# PRODUCT CHANGE NOTIFICATION

Product Category POWER CONNECTORS 20211116-1

Product Group POWER CONNECTORS GROUNDING AND STEEL

ISSUE DATE: 16-Nov-21

Photos/Drawing (where applicable)

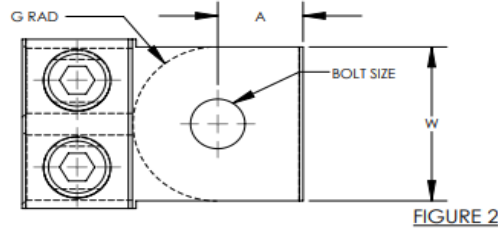
The stud hole 'A' Dimension from the front of the LAM2A250-38-6Y Aluminum Mechanical Lug will be adjusted from .51 (13.0) to .89 (22.5). This will be a running change.
